**From:** Borghmans, Borghert [REDACTED]  
**Sent:** 04 March 2015 14:43  
**To:** Roads Eastern Srit  
**Cc:** [REDACTED]  
**Subject:** Comment on York Street Interchange  
**Attachments:** YSI response BJB 150227.pdf

Thank you for allowing me the opportunity to comment on your Department's proposals for the York Street Interchange. The scheme is greatly needed and I do not oppose its implementation.

### The York Street Flyover

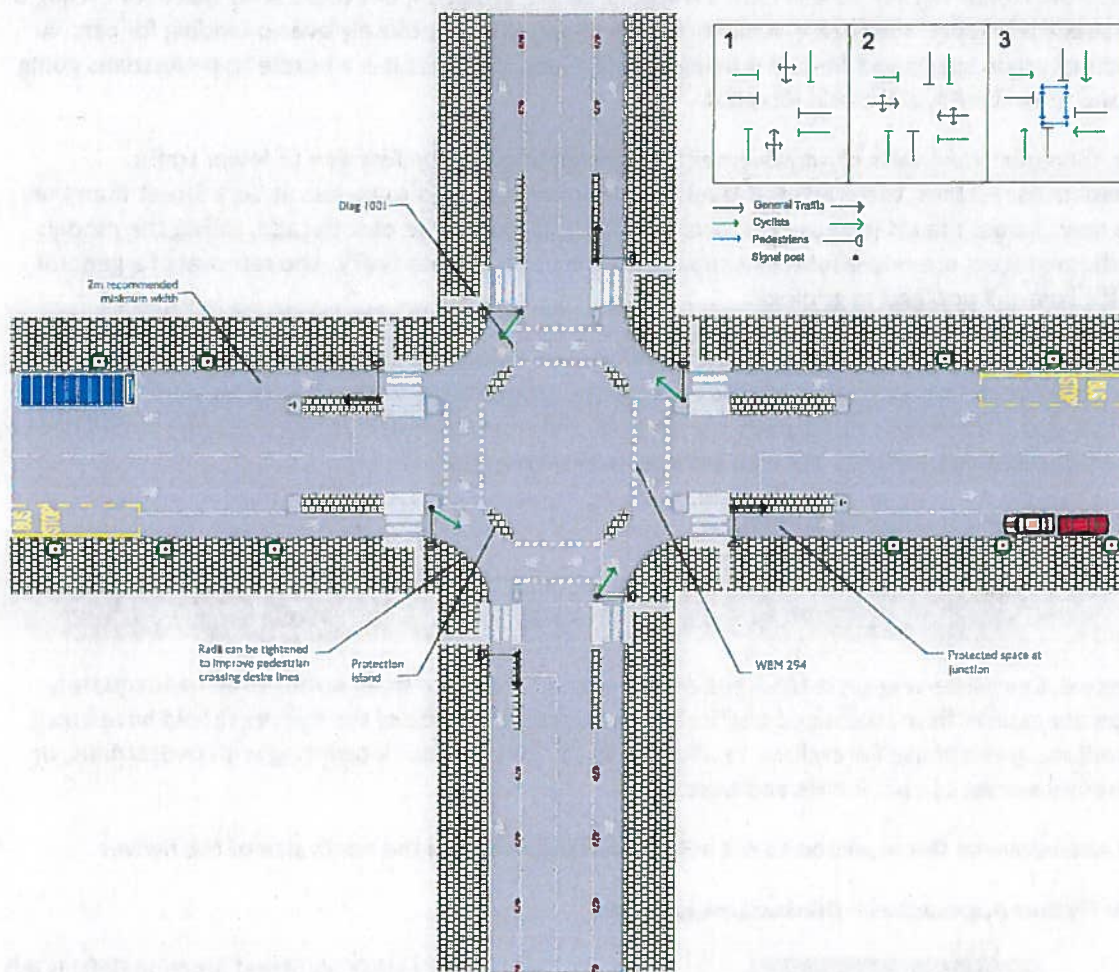
On the other side of the road, country-bound, the plans foresee a 1.5m painted cycle. This lane won't be protected by a kerb. Firstly, the width of the lane is not sufficient to allow for 2 cyclists to go side-by-side without straying into the car space. As a minimum the width should be 2m to allow a faster cyclist to overtake a slower cyclist without straying in to the car lane beside.

The separation by paint is not at all sufficient. Car drivers will see the white line as the safe buffer between them and the cyclist, leading, ironically, to closer overtaking than if no lane was present.

Above is the proposed lay out. The separation of 1.6m between the car lanes is to accommodate double headed traffic lights. It is rather disappointing that more space and safety concern is given to traffic lights than cyclists.

I note that there are 2 running lanes are devoted to traffic from Dunbar Link to Shore Road. When pressed the URS engineer stated this was needed to deal with the traffic flow at that location. This rings untrue because at the city centre side approach there are only 3 lanes of outbound traffic and the left most lane separates out into two at the flyover. Why not continue with the 3 lane layout from Dunbar Link across the flyover?

Bearing in mind the above real life experience we can reduce the Shore Road bound lanes to one and redistribute the space to allow for cycle tracks, separated by kerbs. Ideally we want the gold standard, but the following diagram is a sensible compromise; Dutch design principles would have a 3 to 4m wide two-way cycle track on both sides of such a road.

There is now a one-way cycle track either side with a kerb and a small buffer zone to adequately separate cyclists from motorised traffic. The junctions either side of the flyover should have an all directions green phase for cyclists, to allow them to cross without interfering with pedestrians, or run the gauntlet of cars, lorries and buses.

### The northern approach

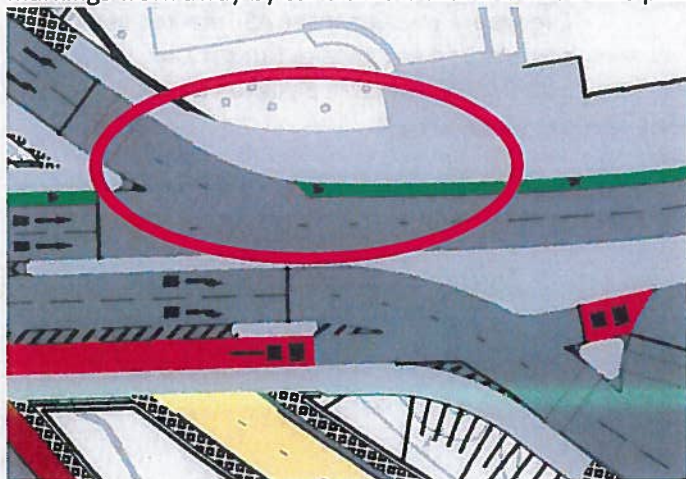
One of the problems of having a painted cycle lane with a sliproad across it is that the paint quickly wears off. Motorists do not slow down to enter the side street, putting pedestrians and cyclists in a very vulnerable position. The A12 offslip cuts across the painted lane and whilst traffic light phasing means cars and cyclists should not meet at the mouth of the lane, the message of cycle lane markings worn away by car traffic is that it is not a safe place for cycling.

#### The Flyover Approaches – Dunbar Link junction

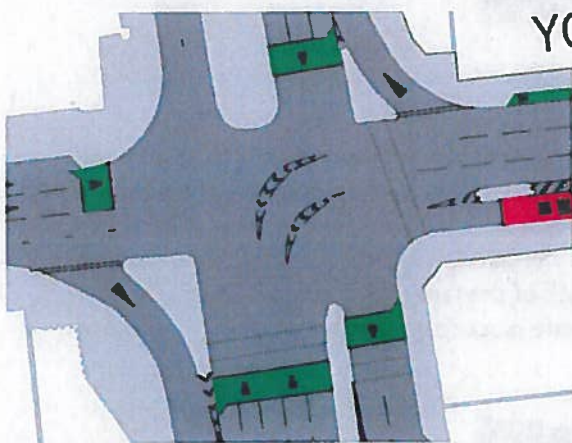
The Dunbar Link/York Street junction (left) is left as it is, but redesigned to accommodate the end of the citybound bus lane. My proposed layout for the flyover can be extended to the junction with the buffer zones (marked in black hatches in the diagram left) removed to accommodate the cycle tracks either side of the road.

The junction has a 5-lane ASL. This is beyond credible, but it actually is the present layout. Even more puzzling is the ASL marked out at the southbound entrance to Dunbar Link. Why, oh why? It is green paint designed to tick boxes but

not designed for cycling: an abomination that needs to be be erased!

The area immediately to the southwest of this junction is going to be dominated by the University of Ulster campus, introducing many thousands of pedestrians and hundreds of cyclists. Rather than waste money on green paint, DRD could really push the boat out and with adaptation introduce a proposed Transport for London junction design that is safe for cycling (below) taken from:

### York Street – floating bus stop

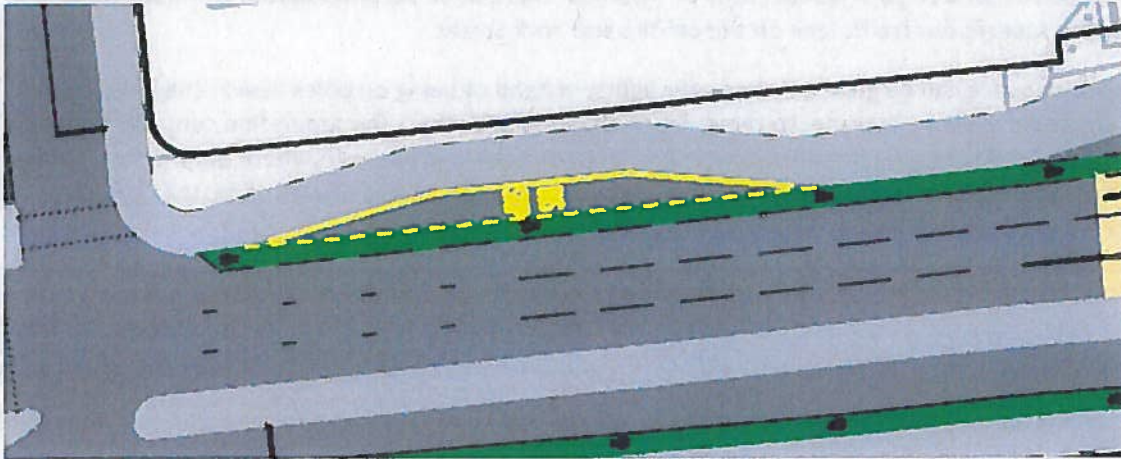
Across the entry to the car park is a bus stop. Here is another example of where cyclists are put in danger by the present proposals. The cyclist might be tempted to overtake the bus at the stop and then find that the bus pulls out. What does the cyclist do? Swerve into the traffic lane, or get run over by the bus pulling out?

A much better arrangement would see the cycle path run to the left of the bus stop, with the waiting area for bus passengers either on the "island" or on footpath.

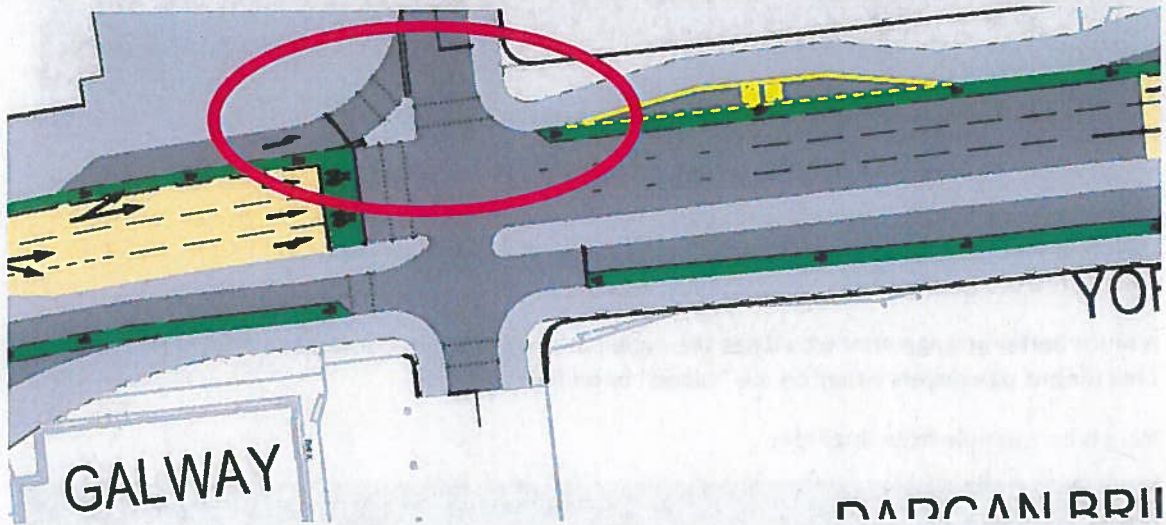
This design helped win Brighton and Hove the 2014 CIVITAS Award for its policies to promote sustainable transport.

The cyclist can pass the bus stop without worrying about traffic behind or buses pulling out. There are visual clues to the cyclist (the tactile paving) alerting them to pedestrians crossing.
